10 Dangar Street Wickham NSW - DA2018/01197

HANNELL STREET (MR316): DA2018/01197, 14 STOREY MIXED USE BUILDING, LOT: 1 DP: 1197377, 10 DANGAR STREET WICKHAM

**STATE ENVIRONMENTAL PLANNING POLICY (INFRASTRUCTURE) 2007
DEVELOPMENT APPLICATION – DA2018/01197
Lot 1 DP 1197377
10 Dangar Street, Wickham NSW 2293
*“Demolition of existing structures and erection of
14 storey mixed use development”***

Drainage Infrastructure

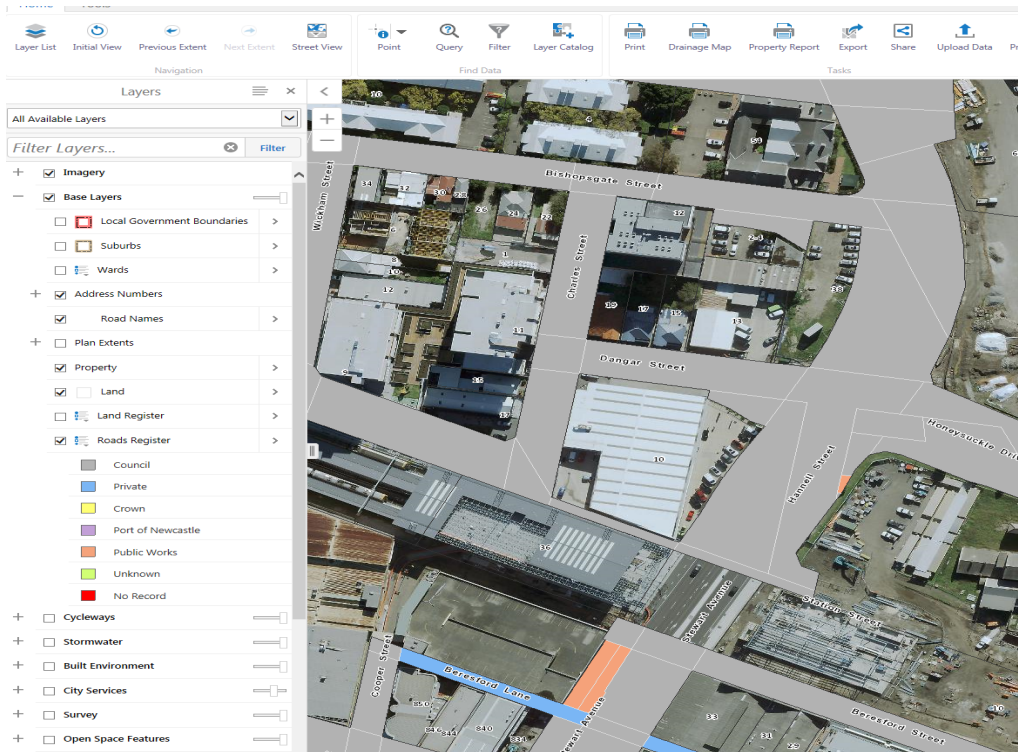
City records indicate that drainage pipes are located along the shared pedestrian pathway on the southern property boundary. The pipe seems to be very close to the property boundary (See image below). The pipe

is approx. 900mm in diameter and new junction pits have been constructed as part of the Wickham Station on Charles St.

In regards to the City's drainage and Hunter Water Sewer pipe infrastructure the applicants have undertaken a more detailed survey of the existing pipes and have nearly accurately located the drainage and sewer pipe (Plan Ref No. DA101 Issue B dated 29/11/2018). The submitted plans confirm that the pipes are within the pedestrian through link, which seems to be within a road reserve. The basement wall design has been amended to be set further within the property to accommodate for the drainage and sewer pipe.
